EASA	AIRWORTHINESS DIRECTIVE
	AD No.: 2014-0207 Date: 16 September 2014 Note: This Airworthiness Directive (AD) is issued by EASA, acting in accordance with Regulation (EC) No 216/2008 on behalf of the European Community, its Member States and of the European third countries that participate in the activities of EASA under Article 66 of that Regulation.
This AD is issued in accordance with EU 748/2012, Part 21.A.3B. In accordance with EC 2042/2003 Annex I, Part M.A.301, the continuing airworthiness of an aircraft shall be ensured by accomplishing any applicable ADs. Consequently, no person may operate an aircraft to which an AD applies, except in accordance with the requirements of that AD, unless otherwise specified by the Agency [EC 2042/2003 Annex I, Part M.A.303] or agreed with the Authority of the State of Registry [EC 216/2008, Article 14(4) exemption].	
Type Approval Holder's Name : AIRBUS	Type/Model designation(s) : A318, A319, A320 and A321 aeroplanes

TCDS Number :	EASA.A.064
Foreign AD :	Not applicable
Supersedure:	This AD supersedes EASA AD 2012-0055R1 dated 17 October 2012.
ATA 35	Oxygen – Chemical Emergency Oxygen Containers – Modification
Manufacturer(s):	Airbus (for

Appendix 1 – Design A of the Passenger Oxygen Containers

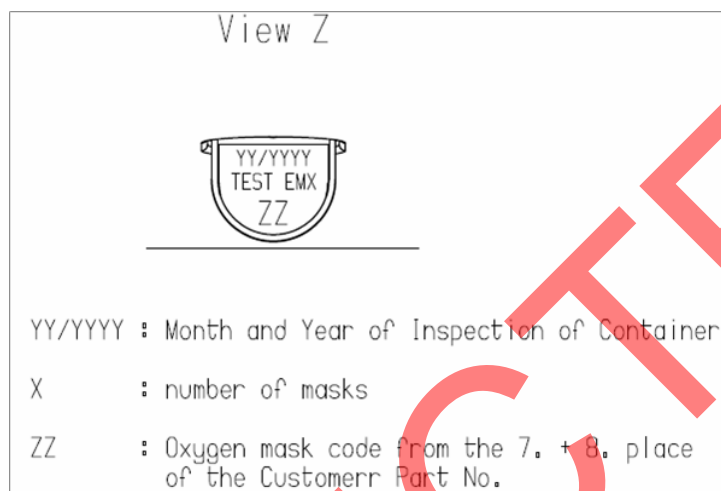
Design A: The placard on the passenger oxygen container test button is as described in Picture A of Appendix 1 of this AD. The Mask configuration ("ZZ" in Picture A) is a number and the test button is as shown in Picture B.
